Comment on Eversource's claimed clearance requirement between OPGW and conductors DE-24-087 and SEC 2024-02

Exhibit B -Testimony of Robert D. Andrew
Petition for Approval of Lease Agreement Between Public Service Company of New Hampshire
d/b/a Eversource Energy and Northern Pass Transmission LLC
Docket No. DE 15-xxx
Page 5 of 13

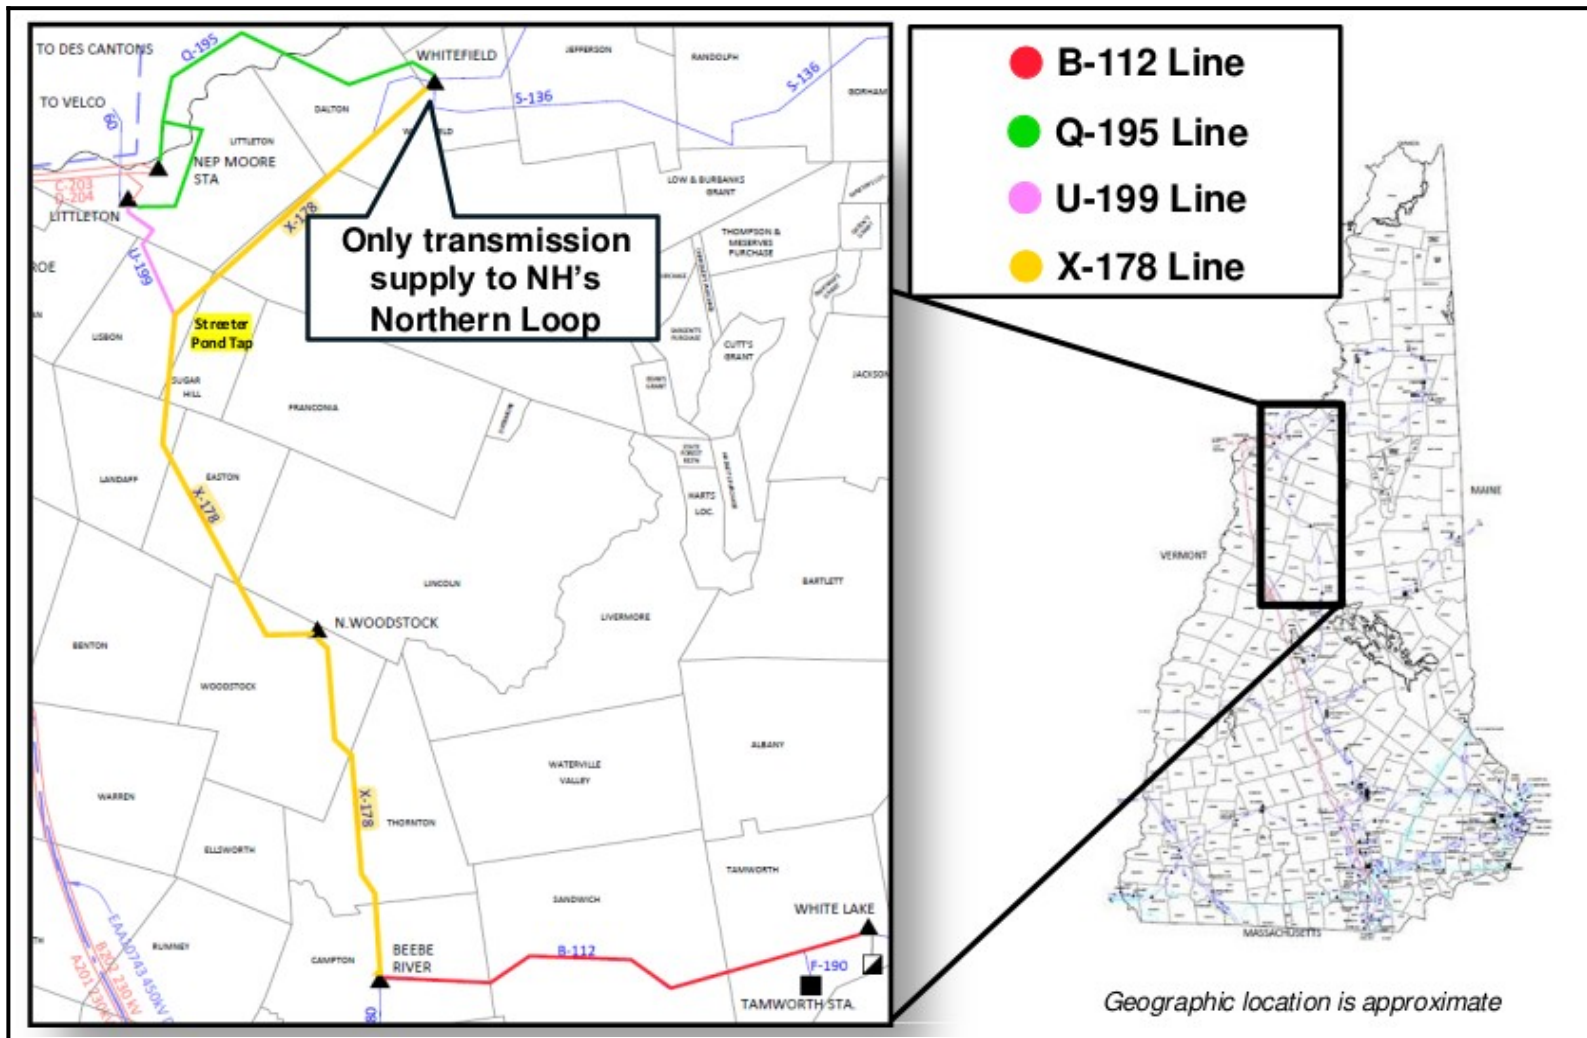
Eversource now claims that the X-178 (3) was built in 1969 with 795 ASCR. Forest Service documents indicate the whole X-178 was built in 1948 and the X-178 (3) was either reconducted or rebuilt with 795 ASCR in 1969.

Is the testimony above incorrect? Where is Eversource’s documentation showing that the X-178 (3) was completely rebuilt in 1969?

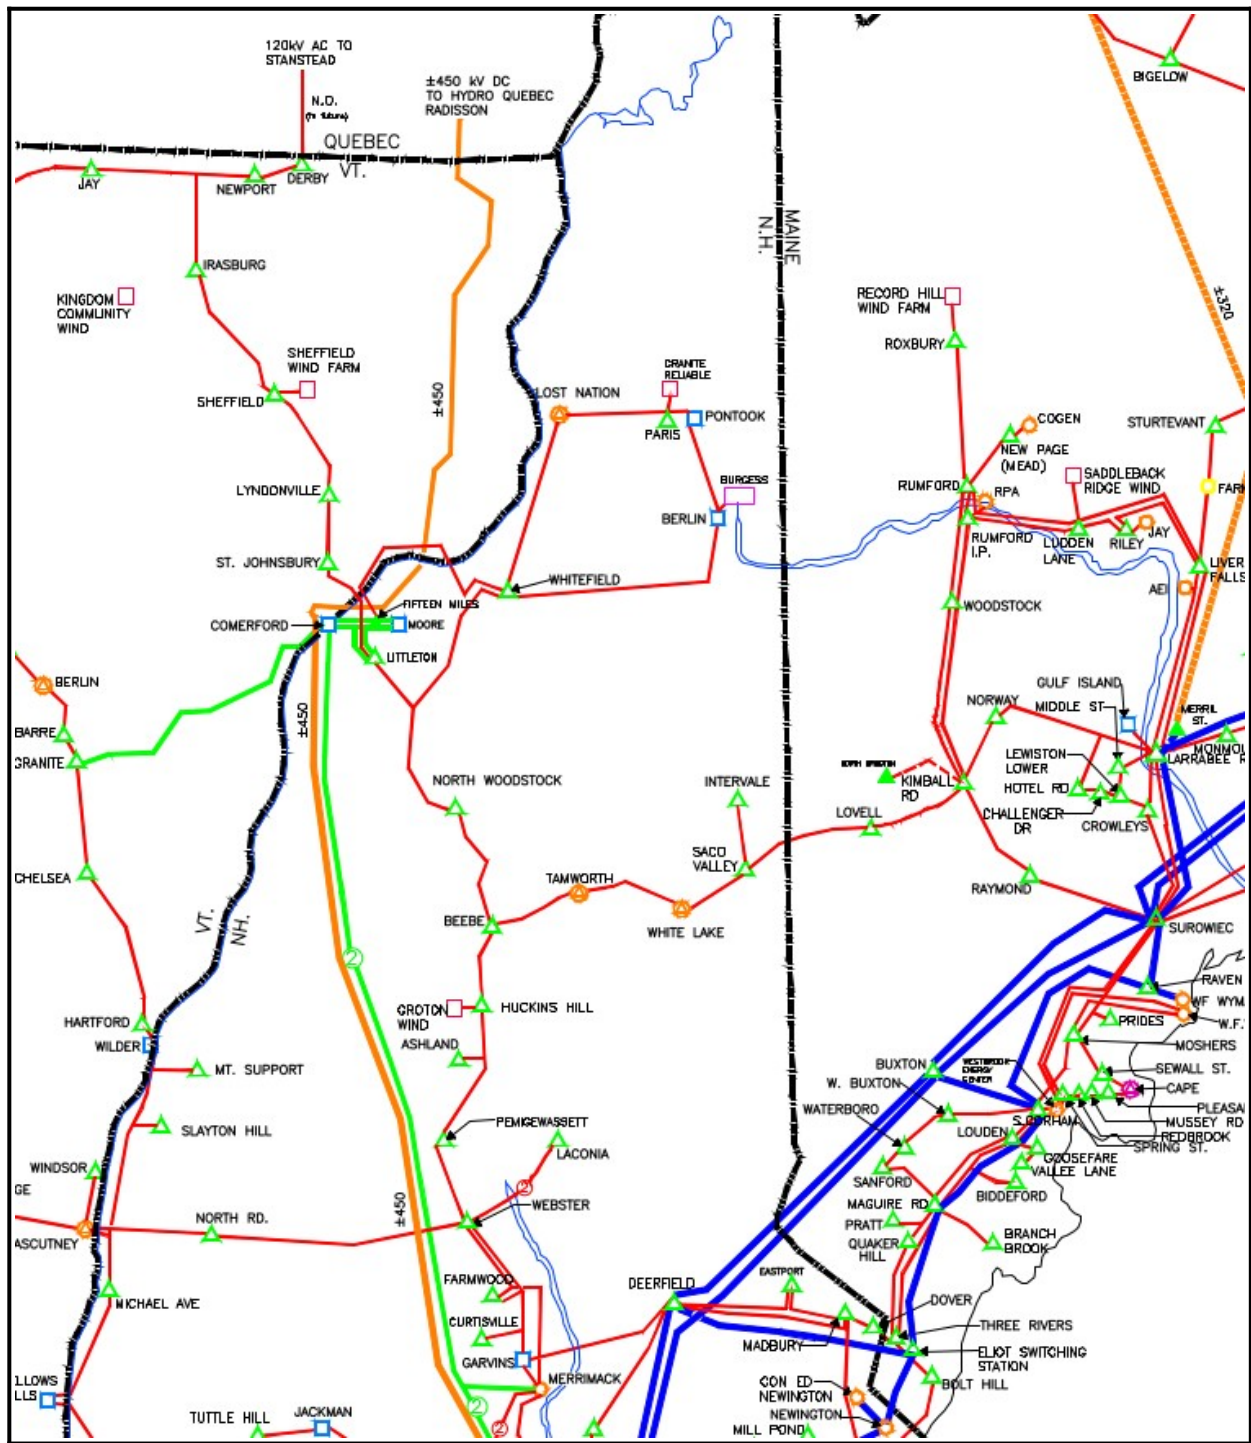
Eversource’s October 22, 2024 presentation to the PAC (it couldn’t be bothered to correct its map) claimed the X-178 asset condition project is of vital importance because the X-178 is the “only transmission supply to NH’s Northern Loop.”

The same map, however, shows that the Coos Loop is connected to the grid via the X-178 (1 & 2) → U-199 → Q-195, and the X-178 (3) → U-199, and the Q-195 from the Moore/Comerford, Vermont.

If one looks at the complete grid map and not just Eversource's map, it appears likely that Eversource will construct a line from the Coos Loop east to Maine and north/northwest, to Hydro-Quebec.
